City of Detroit  
Inter-Departmental Communication

**RE:** Petition No. 1335  
Request for Conversion To Easement The North/South Alley In The block Bound  
By 15<sup>th</sup>, 16<sup>th</sup>, West Warren, And Grand River Ave.

REQUEST TO CONVERT TO EASEMENT  
 THE NORTH/SOUTH PUBLIC  
 ALLEY, VARIOUS WIDTHS  
 IN THE BLOCK BOUND BY  
 15TH, 16TH ST., W. WARREN  
 AND GRAND RIVER AVE.

DRWG. NO. X 1335

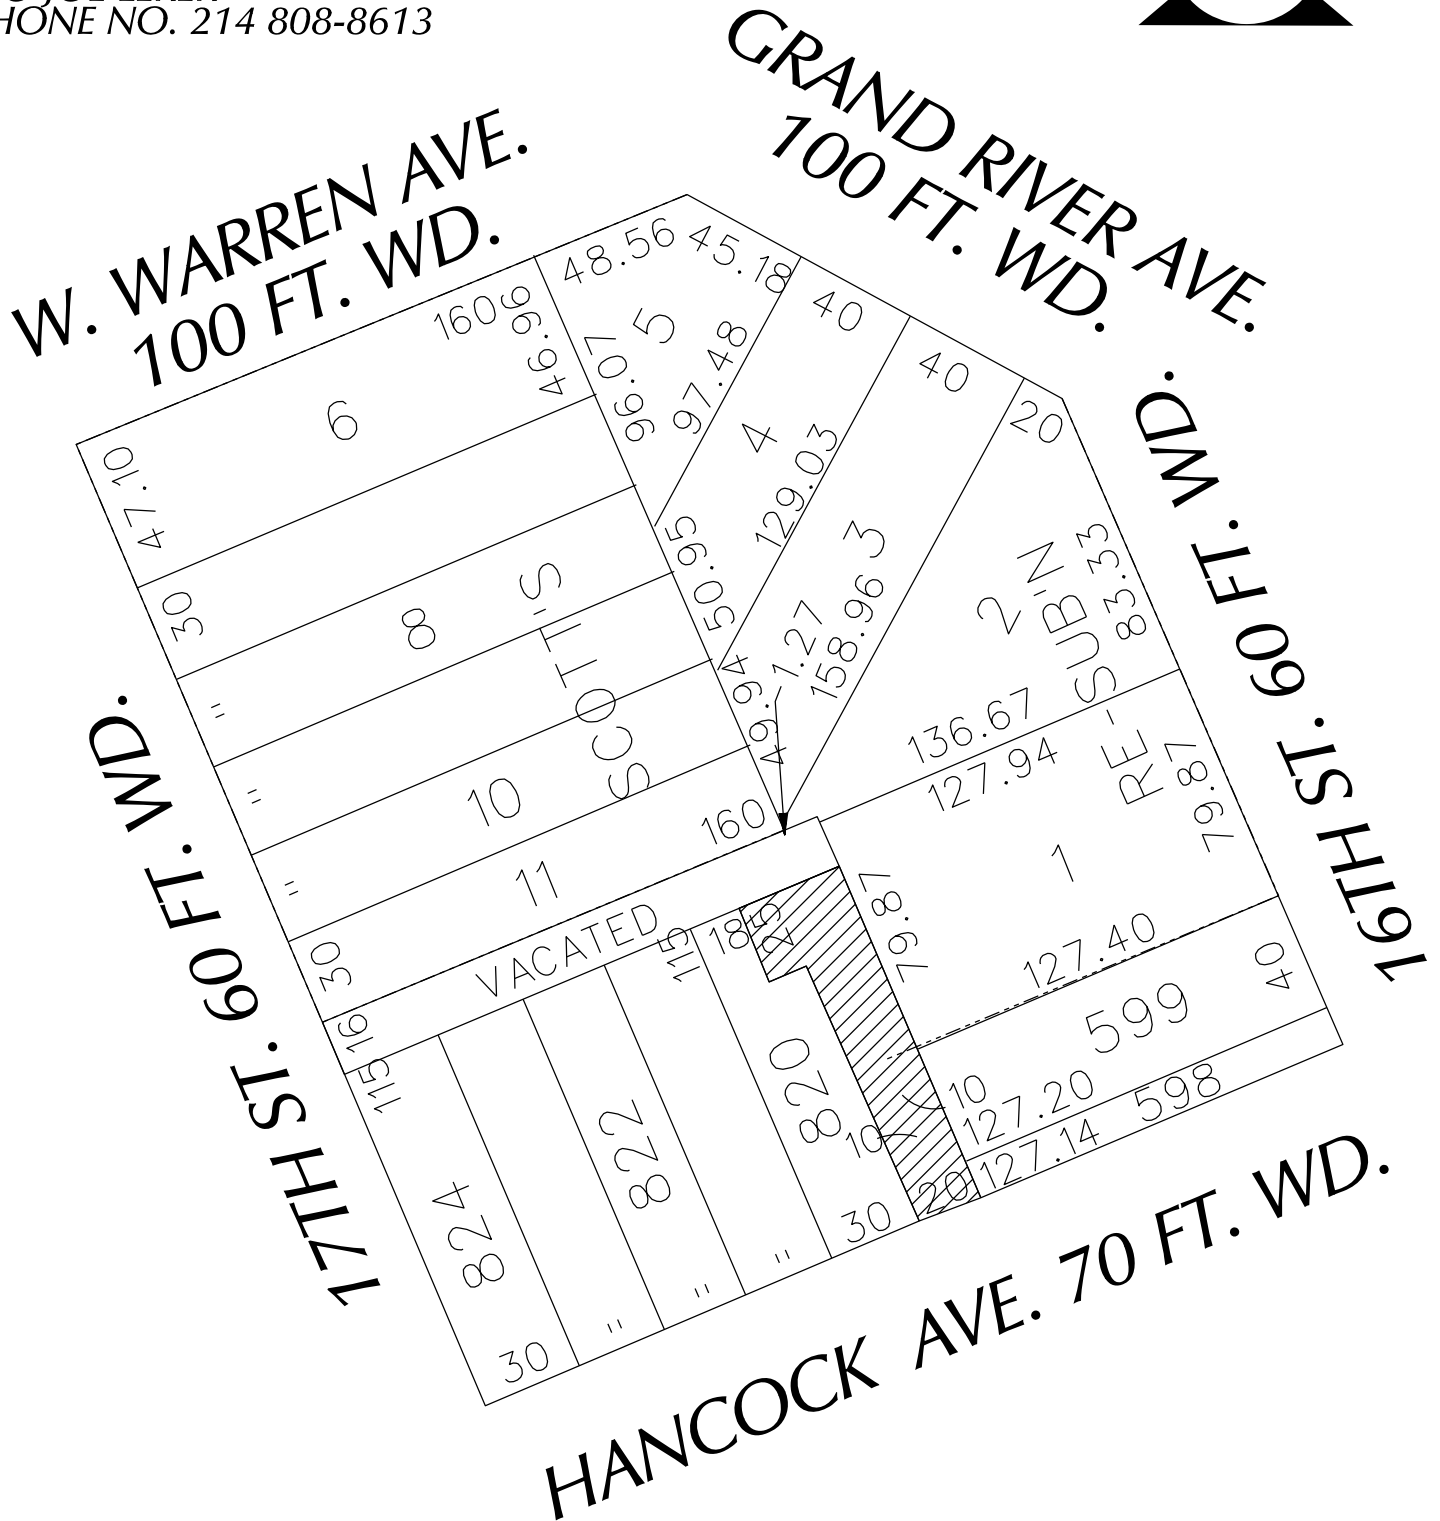
- Our records indicate that there is a sewer in the alley. DWSD has no objection to the requested conversion to easement provided that the attached Provisions for Conversion to Easement are strictly followed.

1. An easement, the full width of the existing right of way, is reserved for the Detroit Water and Sewerage Department for the purpose of installing, maintaining, repairing, removing, or replacing any sewers, water mains, fire hydrants and appurtenances, with the right of ingress and egress at any time to, and over said easement for the purpose above set forth.

2. Said owners of the adjoining property, for themselves, their heirs and assigns, agree that no building or structure of any nature whatsoever, including fences, porches, patios, balconies, etc., shall be built upon or over said easement, or that no grade changes or storage of materials shall be made within said easement without prior written approval and agreement with the Detroit Water and Sewerage Department.

3. If at any time in the future, the owners of any lots abutting on said vacated right of way shall request the removal and/or relocation of the aforementioned utilities in said easement, such owners shall pay all costs incident to such removal and/or relocation. It is further provided that if sewers, water mains, and/or appurtenances in said easement shall break or be damaged as a result of any action on the part of the owner, or assigns, then in such event, the owner or assigns shall be liable for all costs incident to the repair of such broken or damaged sewers and water mains, and shall also be liable for all claims for damages resulting from his action.
